The **City of Stoughton** will hold a joint meeting of the **Planning Commission and Business Park North Committee** on **Monday, June 13, 2011 at 5:30 pm**, in the **Council Chambers**, Second Floor, **Public Safety Building**, 321 S. Fourth Street, Stoughton WI.

**RE: Proposed Pharmacy Audit Assistance Services**

I have completed a review of the proposed new building at Park Place, 160 Business Park Circle - Plan submitted 6/7/11. As noted, additional information may be required to be provided or shown on the plan.

PHOTOMETRIC PLAN  
C-14 SCALE: 1" = 20'-0" NORTH

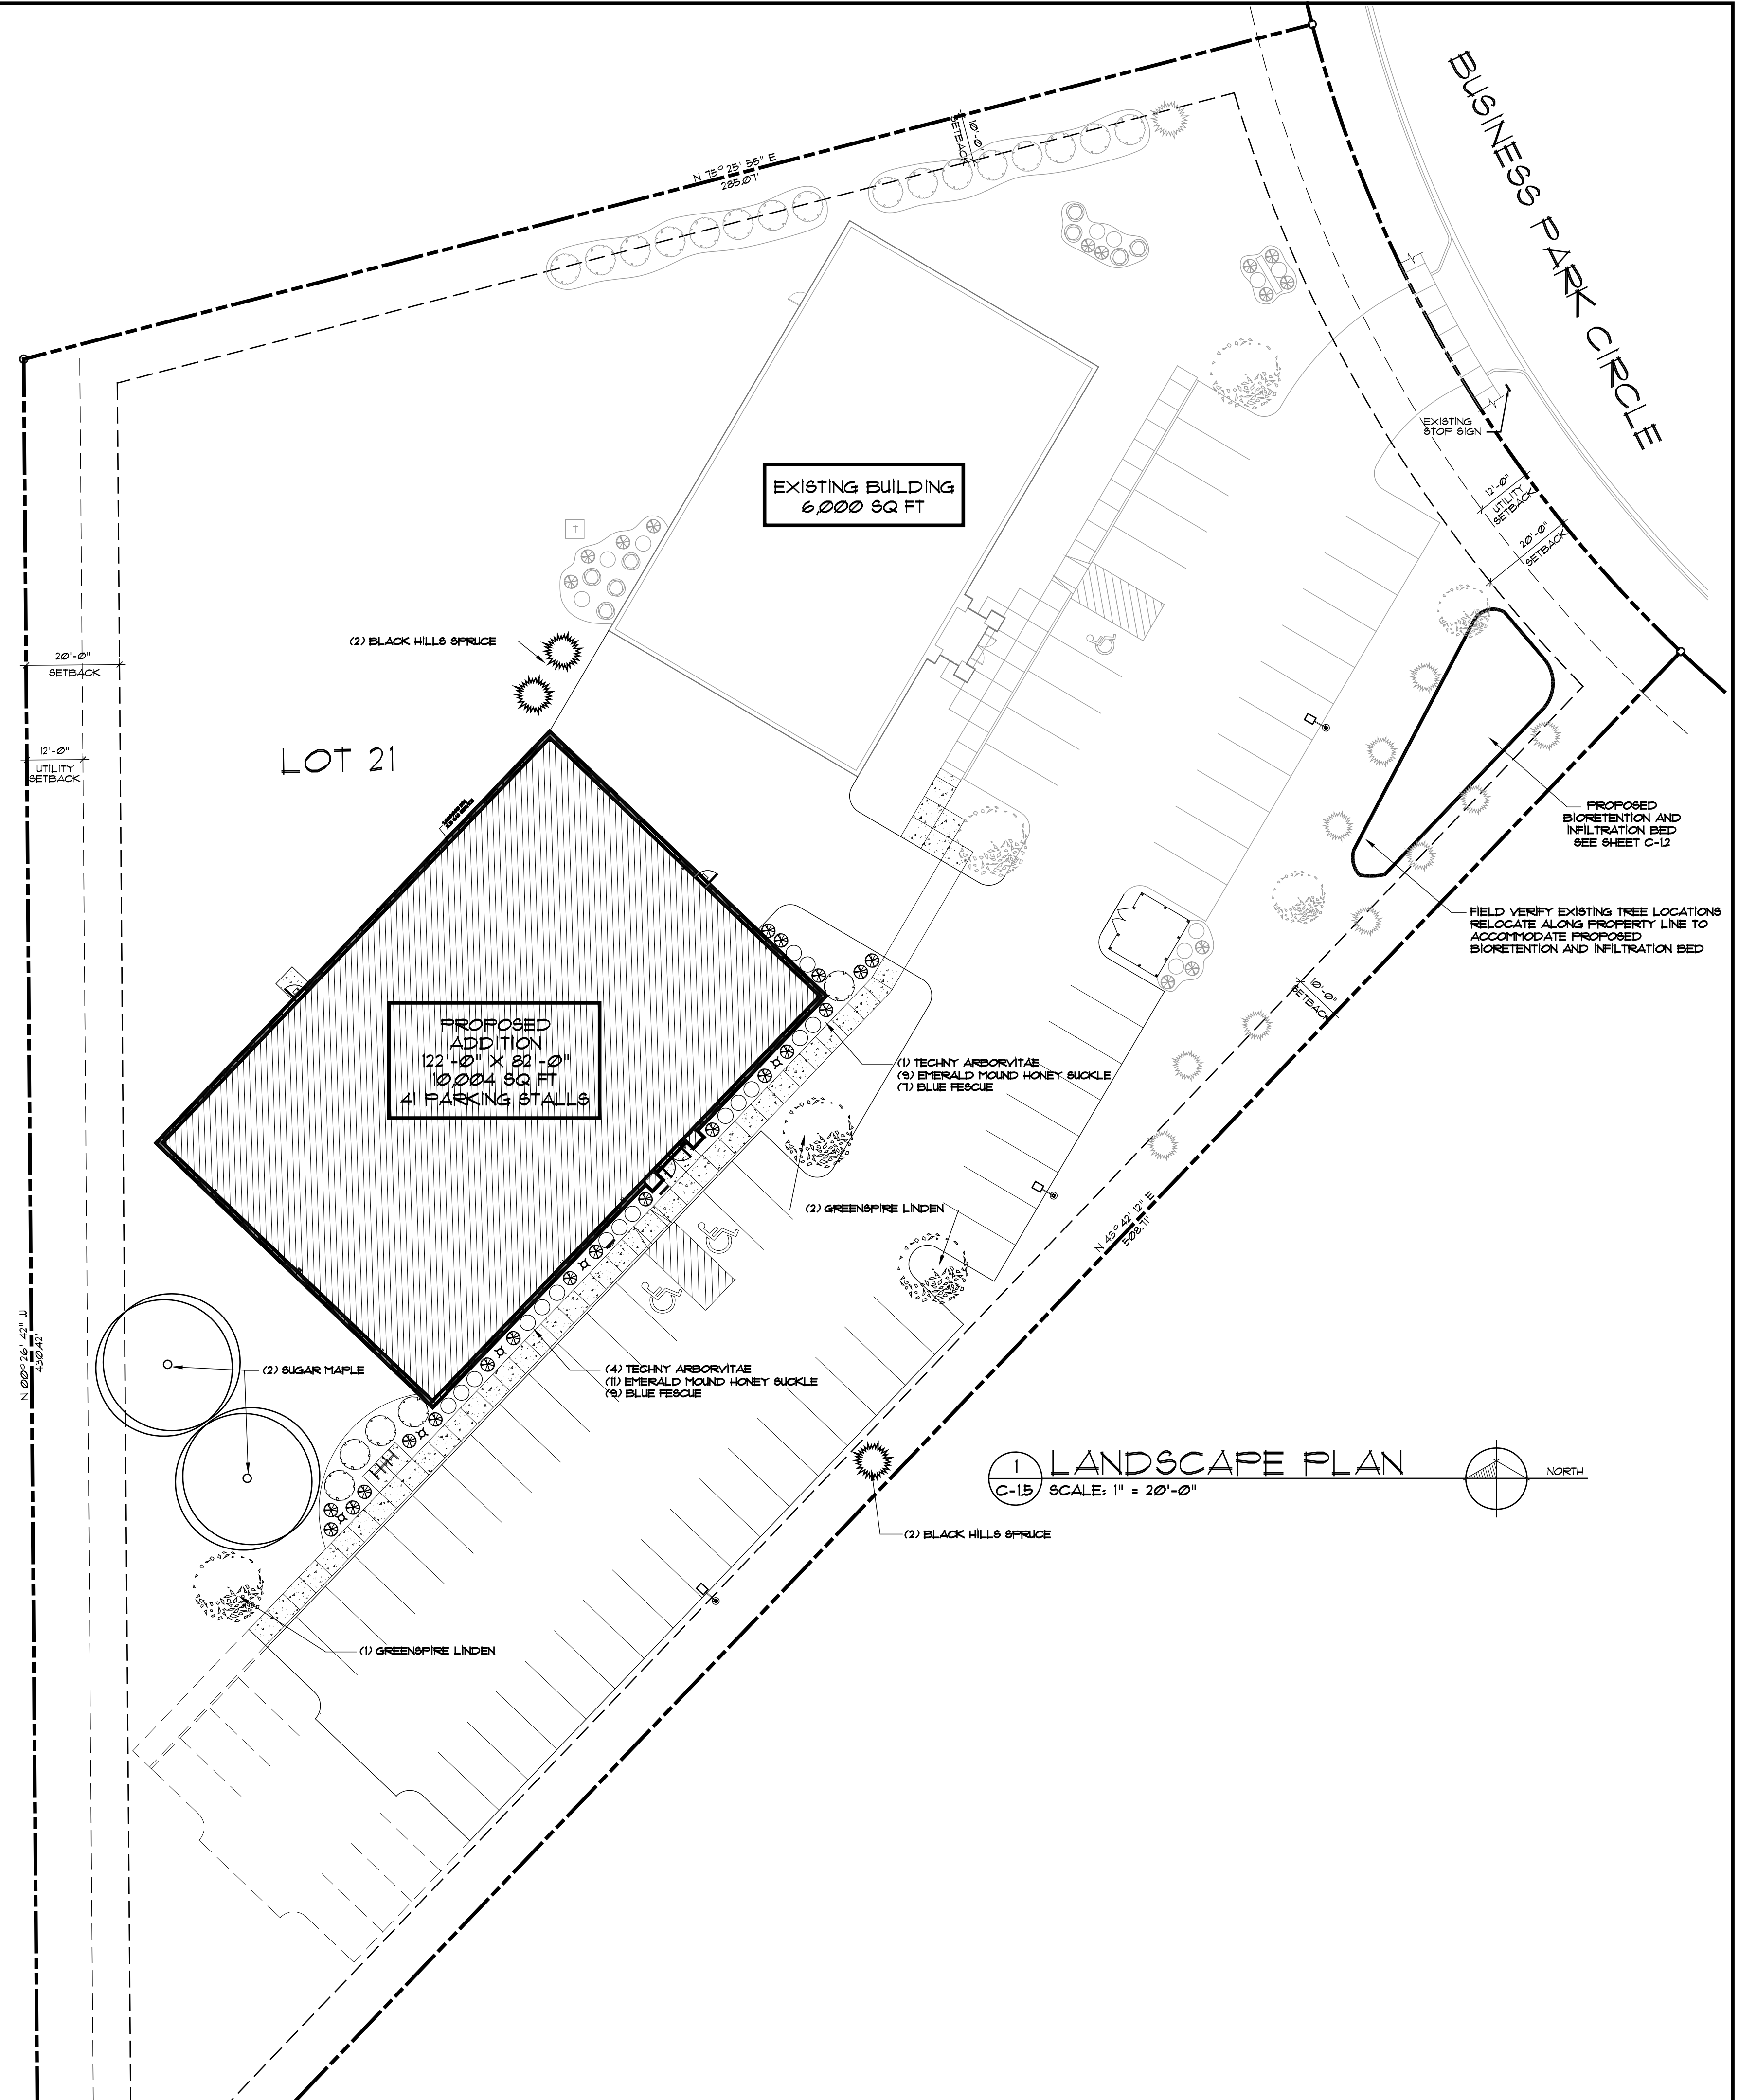
10. Article VII of the city zoning code provides the following requirements related to lighting:  
“Parking and traffic circulation areas serving 6 or more vehicles shall be lit so as to ensure the safe and efficient use of said areas during the hours of use. An illumination level of between 0.4 and 1.0 footcandles is recommended for said areas, and said illumination shall not exceed 0.5 footcandles measured at the property lines.” **This requirement is not necessary if the parking, loading and circulation areas are not used after sunset. A photometric plan has been submitted to meet this requirement.**

11. Section 78-707, Exterior lighting standards, requires a maximum average on-site lighting of 2.4 footcandles. The maximum lighting as measured at the property line is 0.5 footcandles. **The proposed lighting complies with this requirement.**

- c. Exterior signs. **There is an existing sign. No additional signage proposed.**
  - d. Exterior Lighting. **The provided photometric plan meets the zoning code requirements.**

**LANDSCAPE POINTS**

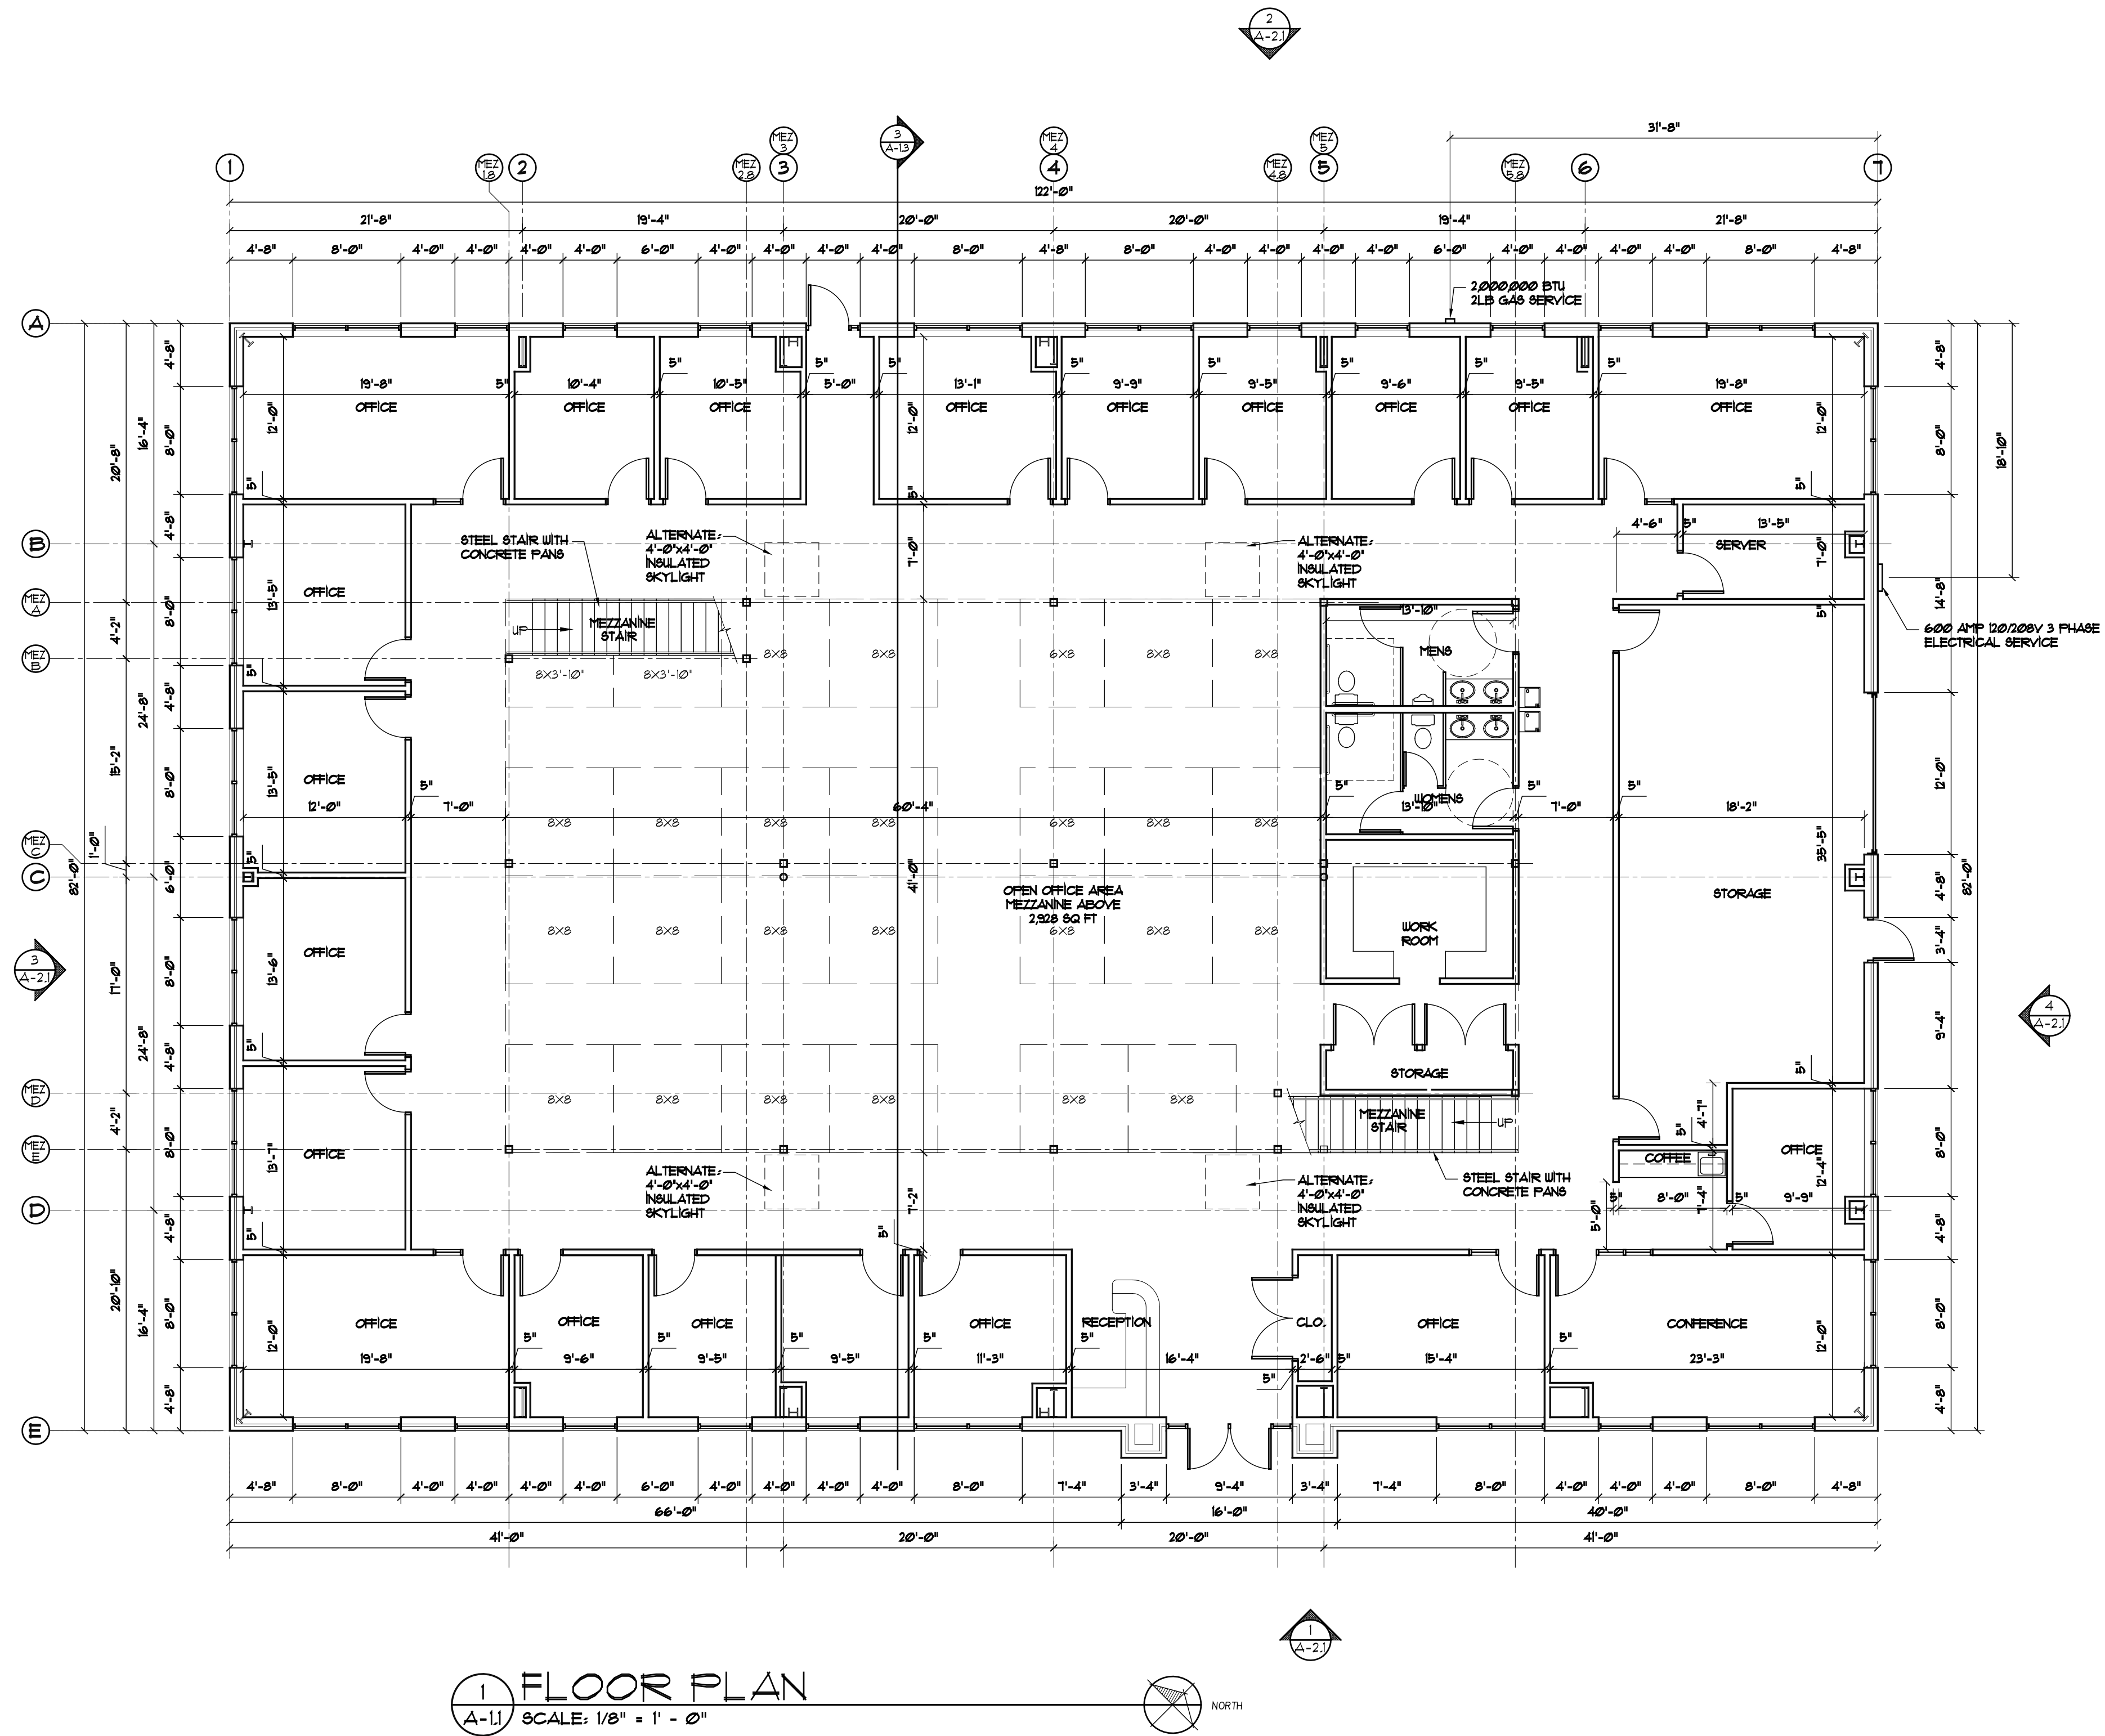
8. A landscaping plan which meets the requirements of section 78-604 must be provided. This section requires 164 landscaping points for the building foundation; 123 landscaping points are required for the new paved area; 100 landscaping points are required for developed lots. **See section 78-604 for additional landscaping requirements. The provided landscaping plan meets these requirements.**
